memorandum

subject Additional information request to support Water Resources portion of the Fairhaven DEIS **DRAFT**

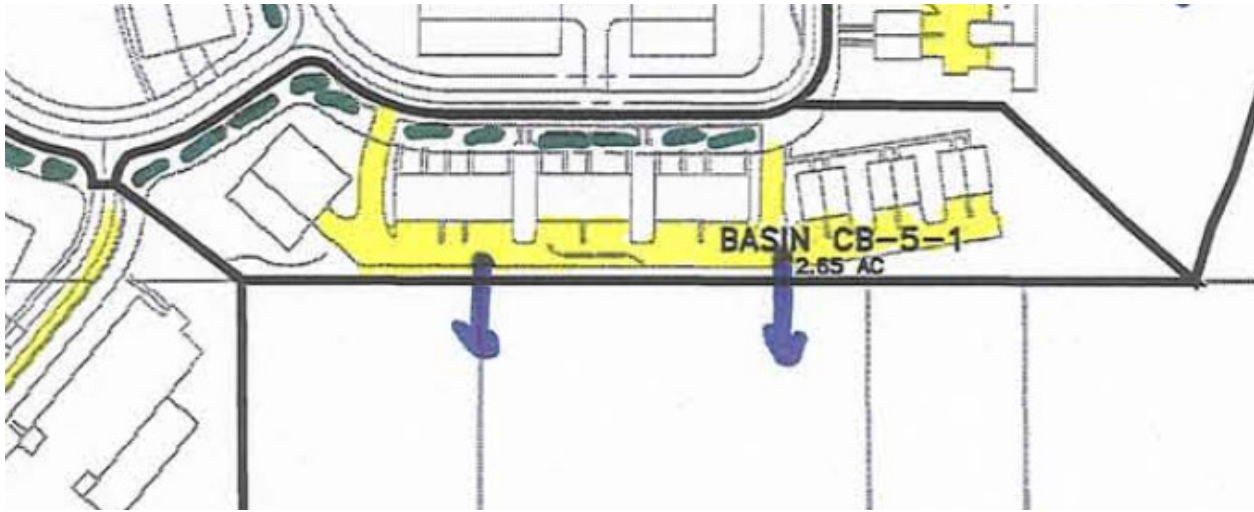
3. Basin CB-5-1: Please comment on the use of dispersion to adjacent private property, as shown in the portion of figure EX-8 from the Stormwater Site Plan, below.
